Access Compliance Report

Public Rights-of-Way

(Curb Ramps)

Intersection ID: 53415	Main Street: PROVIDENCE_RD	Cross Street: SOUTHGROVE_ST	Location: SW
ADA ID: A76F9A7A4CDF	Ramp Type: Para	Initial Pass/Fail: Fail	Overall Compliance: No
Severity Score: 26.25			
Codes/Mitigation Info/Possible Solution		Field Measurements/Component Compliance

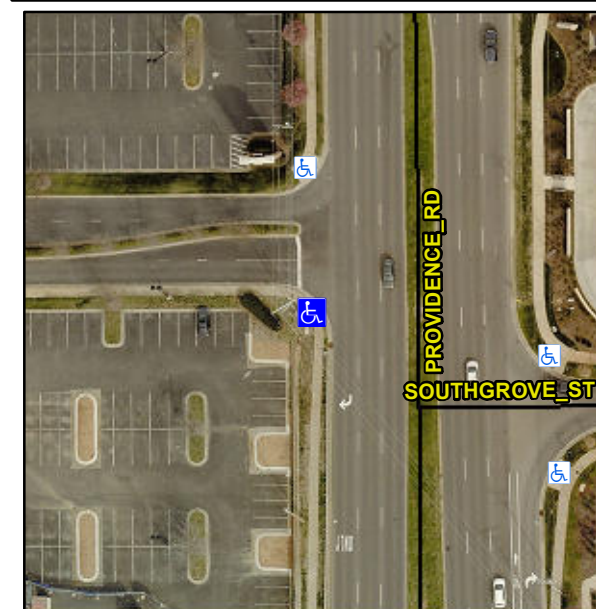
R304.3.2, R304.5.3

Compliance	Description	Data	Compliance	Description	Data
N/A	Ramp Length LT (in)	58.0	N/A	Ramp Length RT (in)	54.0
Yes	Ramp Width LT (in)	68.0	Yes	Ramp Width RT (in)	68.0
No	Ramp Slope LT (%)	13.3	Yes	Ramp Slope RT (%)	5.1
Yes	Ramp XSlope LT (%)	1.1	No	Ramp XSlope RT (%)	2.3
N/A	Landing Length (in)	N/A	N/A	DWS Provided?	N/A
N/A	Landing Width (in)	N/A	N/A	DWS Contrast?	N/A
N/A	Landing Slope (%)	N/A	N/A	DWS Length (in)	N/A
N/A	Landing X Slope (%)	N/A	N/A	DWS Full Width?	N/A
N/A	Landing Curb? (Y/N)	N/A	N/A	DWS Offset (in)	N/A
N/A	Shared Landing?	N/A			
N/A	Gutter Ponding?	N/A	N/A	Gutter Slope (%)	N/A
N/A	Gutter Lip Ht (in)	N/A	N/A	Gutter X Slope (%)	N/A
N/A	Painted X Walk1?	No	N/A	Painted X Walk2?	N/A
	X Walk 1 Direction	To N		X Walk 2 Direction	N/A
N/A	X Walk 1 Width (in)	N/A	N/A	X Walk 2 Width (in)	N/A
	X Walk 1 Slope (%)	0.8		X Walk 2 Slope (%)	N/A
	X Walk 1 X Slope (%)	0.5		X Walk 2 X Slope (%)	N/A
N/A	Ramp inside XWalk1?	N/A	N/A	Ramp inside XWalk2?	N/A

Road Slope (%)	N/A	N/A	Clear Space?	N/A
	Road X Slope (%)	N/A	N/A	Clear Space to XWalk (in)	N/A
N/A	Any Obstructions?	N/A	N/A	Storm Grate/Utility Hazard?	N/A
	Obstruction Type			Storm Grate/Utility Type	
		N/A			N/A
			Yes	Surface Condition? (G/P)	Good
			N/A	Curb Slope (%)	4.8

Remove & Replace Entire Ramp.
